SERVICE BULLETIN

MODEL NAME : Di620
MODEL CODE : 1155
NO. : 010
DATE : 981001
SUBJECT : EDGE COVER CHANGE

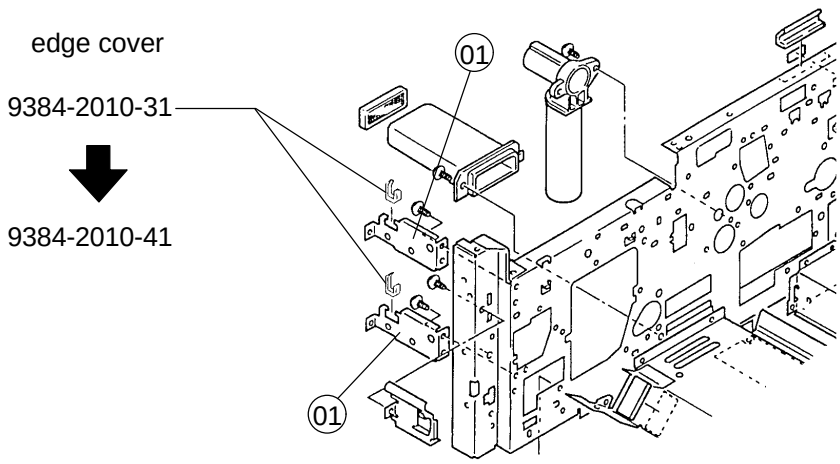
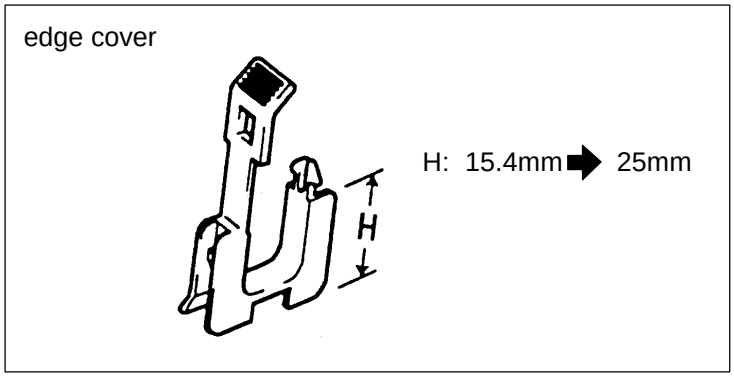
To increase production efficiency, the size of the edge cover has been increased and the harness has been made easier to install. Due to this, the dimensions of the bracket (01) have been change at the cutout for the edge cover.

NOTE: If the new bracket (01) is installed in premodification machines, the new edge cover (9384-2010-41) must be installed with it.
